FINAL DRAINAGE REPORT
for
ROLLIN RIDGE FILING NO. 1

October 21, 2019
Revised February 28, 2020

JPS Project No. 081702
PCD File No.: SF-19-022

HORZ. SCALE: 1"=100'
VERT. SCALE: N/A
SURVEYED: N/A
CREATED: 9/13/17
PROJECT NO: 081702
SHEET: D1.1

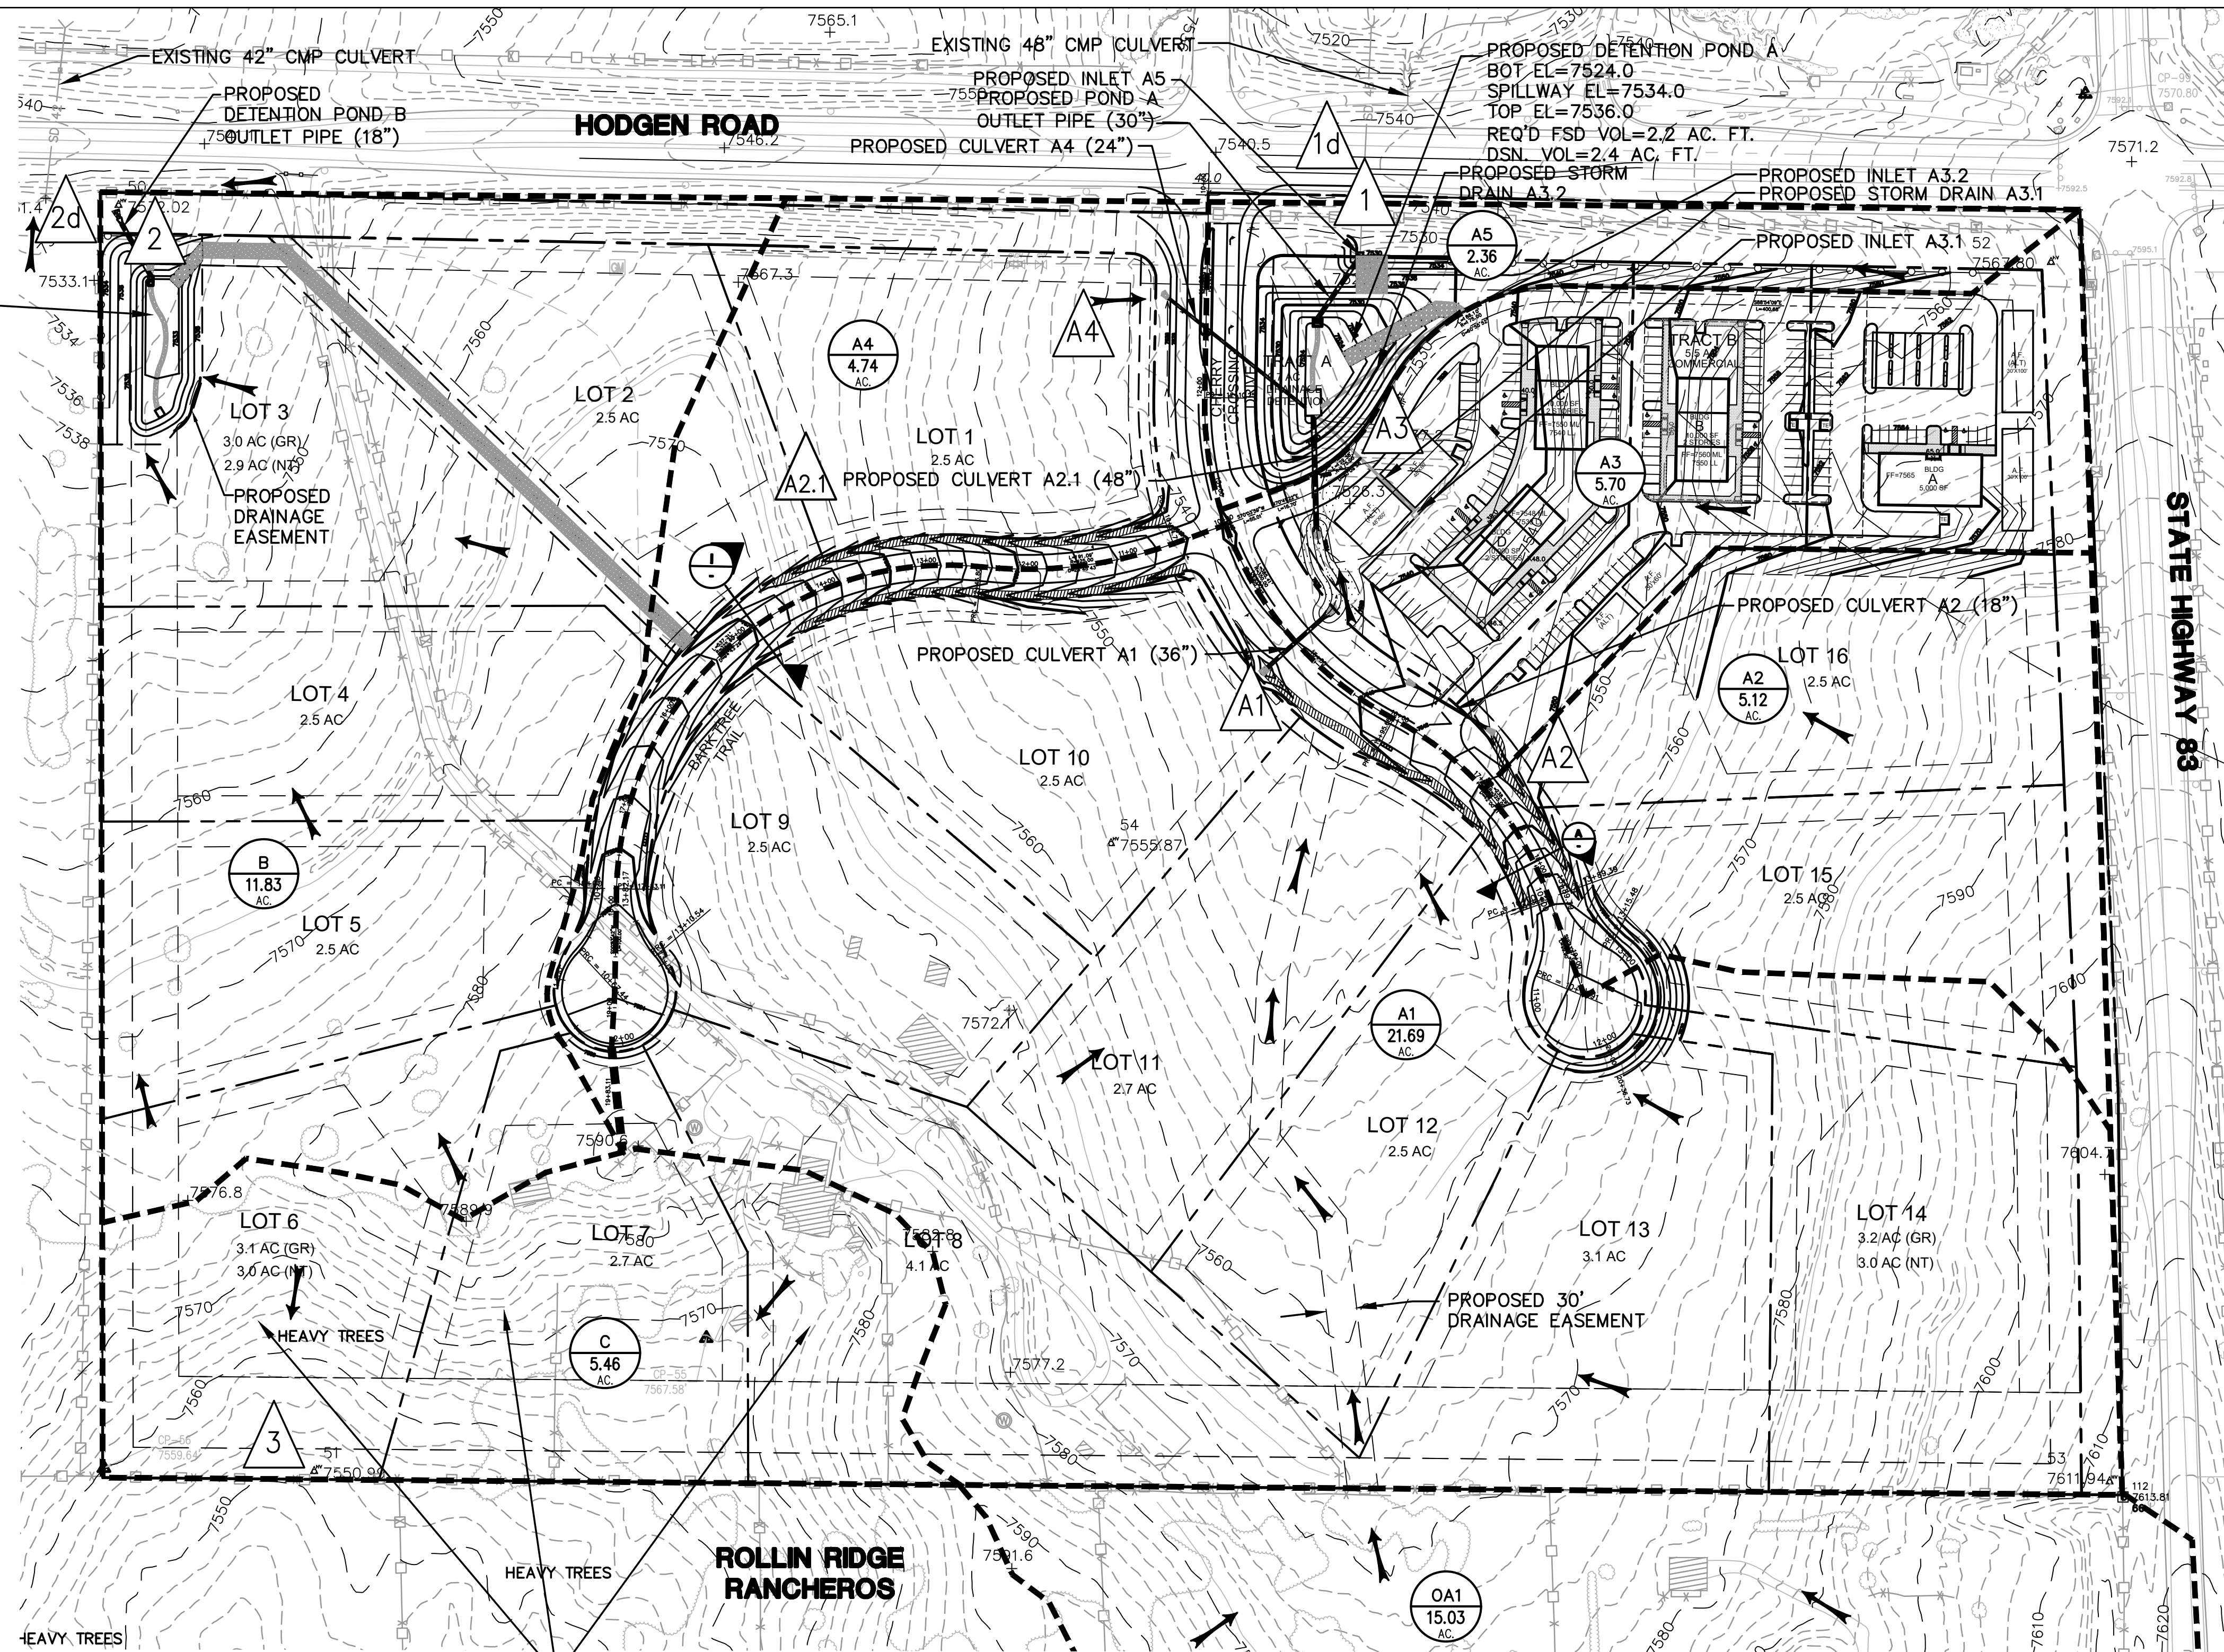
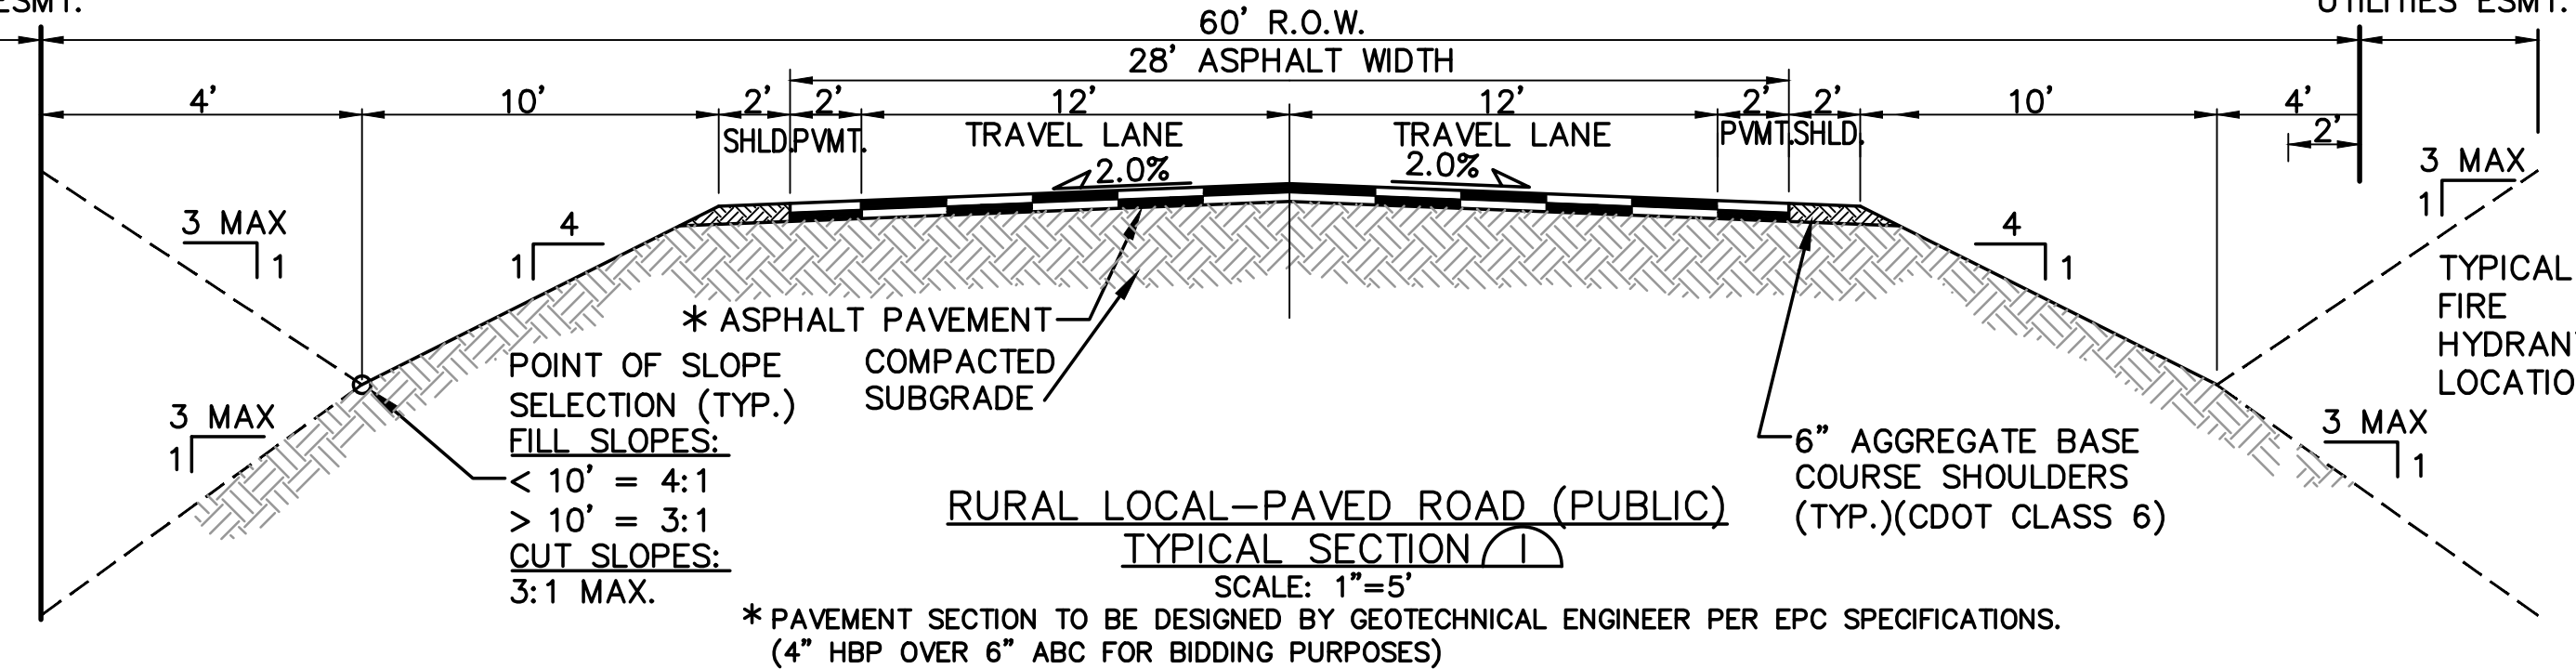
For Section D provide a narrative stating why no WQ is required for basin C. Unresolved. Update to reference the specific ECM criteria for exclusion of permanent water quality. See ECM Appendix I.7.1.B.5 and state whether basin C will meet this exclusion. If it does, you will have to condition that lots in basin C cannot exceed a total lot impervious area of 10 percent. If it does not, then review if the other excluded sites applies or else WQCV is required.
